B0684x MAIN FIRMWARE RELEASE NOTES

WM-Nano Table Top Automatic Wrapper with PK-260A CPU Board

B0684x PK-260A with CF Memory Card Slot

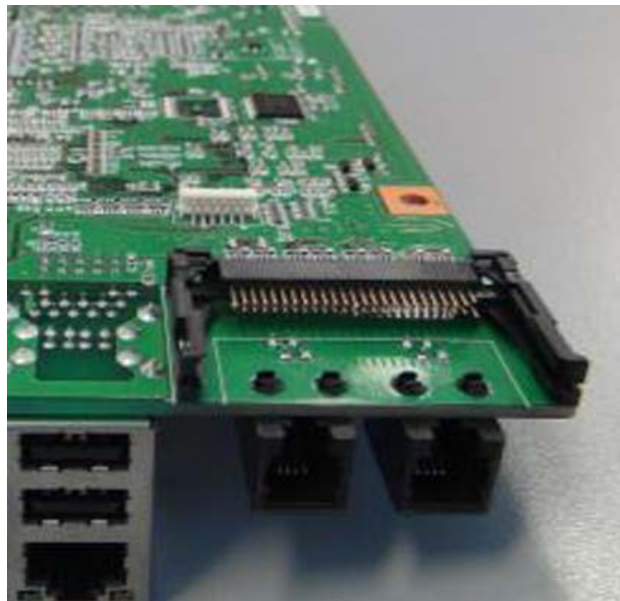
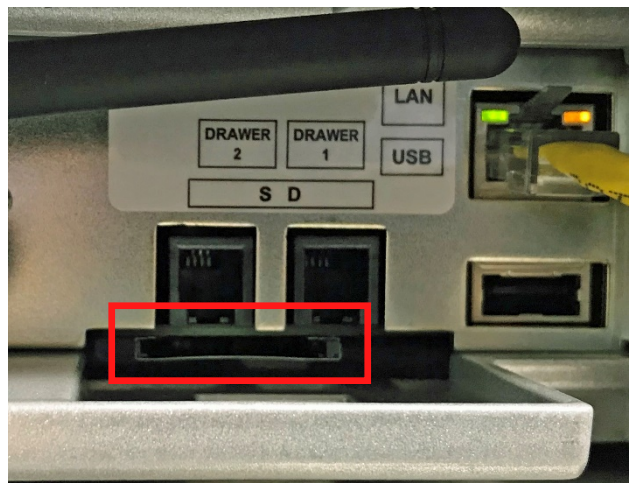
Firmware B0684x is designed for the original CPU board PK-260A. **This firmware is not compatible with the revised CPU board PK-260B.** And new firmware (B0760x) is not compatible with the original PK-260A CPU board.

The two CPU board versions can be easily identified by the expansion memory card slot located on the left side of the Uni-7 controller. See the images on the next page.
